ITEMS RECEIVED AFTER THE PRODUCTION OF THE REPORT
FOR THE PLANNING COMMITTEE
TO BE HELD ON 9 OCTOBER 2025

Application No.: 2025/00493/RG3	Case Officer: Mr Huw Davies
Location: Sully to Cosmeston Active Travel Route Proposal: Works for a shared pedestrian and cycle route (Active Travel Route), earthworks, landscaping and associated works from Sully to Cosmeston.

Subject: RE: Planning Ref: 2025/00493/RG3 - Sully to Cosmeston Active Travel Route

Need to consider alternatives.

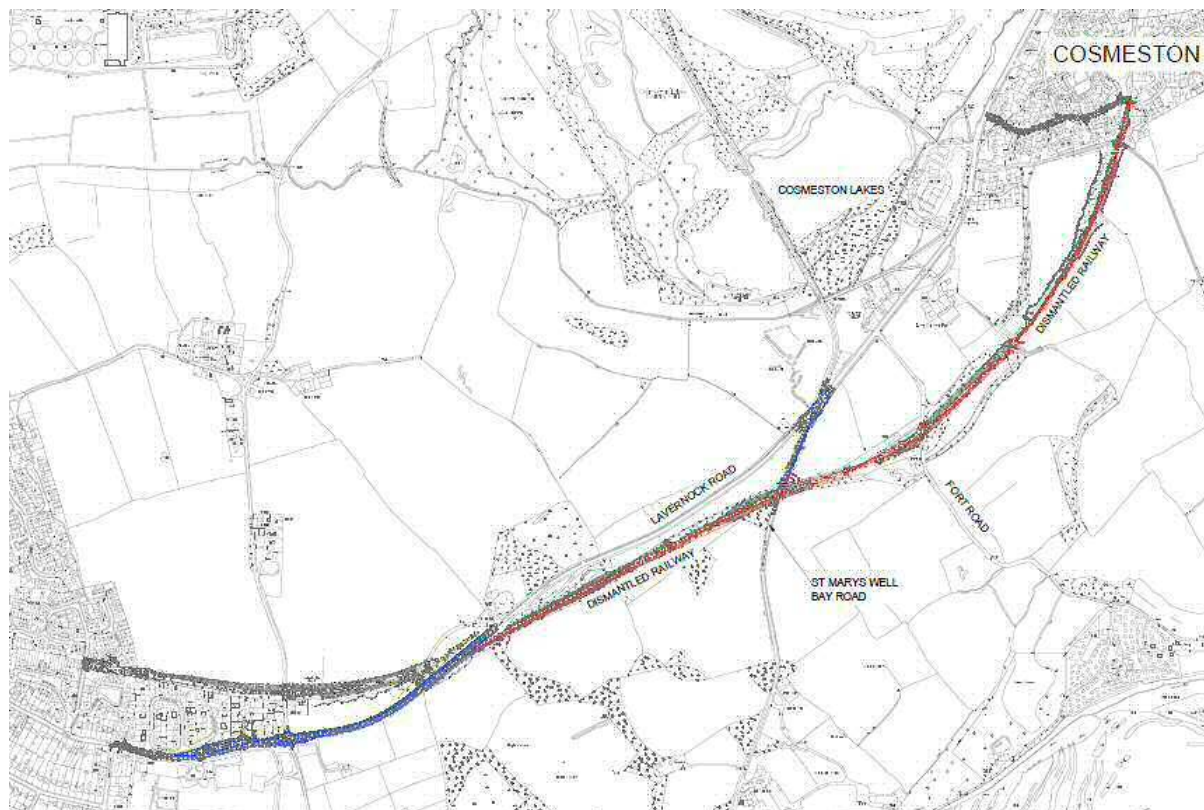
The proposal gives just the single choice, though EIA regulations require the presentation of alternatives considered.

One is that the route from Sully to the Vineyard continues as a roadside 3-m route down to the Cosmeston Mile Rd entrance, avoiding the Sully woodland. A crossing there with a link up to the present route or a 3-m cycleway along the Lavernock Rd verge are two options. This is not only cheaper, but would find it easier to meet the biodiversity requirement (in the form required by PPW)
